乐鑫 ESP32-C5 系列产品升级 Upgrade of ESP32-C5 Series Products			
PCN 编号 PCN No.	PCN20251201	提出日期 Issue Date of PCN	2026/02/27
变更日期 Proposed Date of Change	2026/04/30	预计变更后产品首次 出货日期 Proposed Date of First Shipment After Change	2026/05/30
PCN 类型 PCN Category	<input checked="" type="checkbox"/> 客户需要批准/ Customer Approval Required <input type="checkbox"/> 客户通知/ Customer Notification

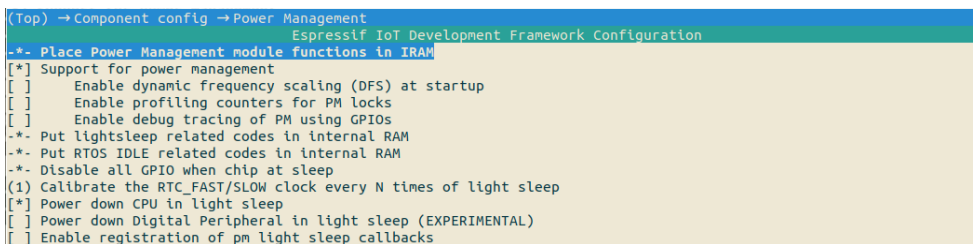
iii) 如使用芯片版本 v1.2 的 HUK 功能或(和)额外获得约 6 KB SRAM 和 20 KB flash 空间时，需执行 i)， “menuconfig” 中需配置 “Minimum Supported ESP32-C5 Revision”：

运行 ESP-IDF 的工程配置工具“menuconfig”时，将“Minimum Supported ESP32-C5 Revision”(> Component config > Hardware Settings > Chip revision) 设置为“Rev v1.2”。默认值是“Rev v1.0”。

注意：若将“Minimum Supported ESP32-C5 Revision”配置为“Rev v1.2”时，固件无法兼容 ESP32-C5 芯片版本 v1.0 及之前芯片版本。

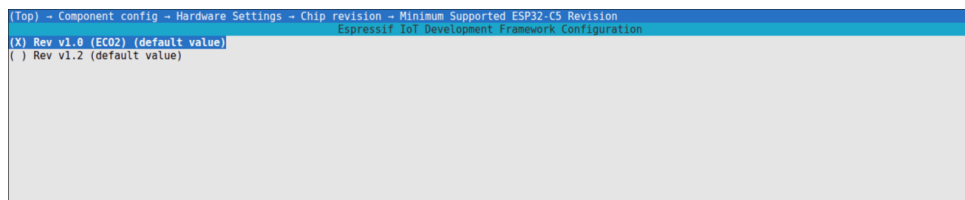
- ii) When using the digital peripheral power domain power-down feature on chip revision v1.2, approximately 100 μ A of sleep current can be saved. Item (i) and the following configuration must be applied:

Run the ESP-IDF project configuration tool menuconfig, and set “Power down Digital Peripheral in light sleep” (> Component config > Power Management) to “y”. The default value is “n”. Please refer to the [documentation](#) for details on using this configuration.

In other cases (for example, when using ESP32-C5 chip revision v1.0 or earlier, or when leaving the “Power down Digital Peripheral in light sleep” option at its default value of “n”), the product’s light-sleep mode operates normally, but no $\sim 100 \mu$ A reduction in sleep current is achieved.
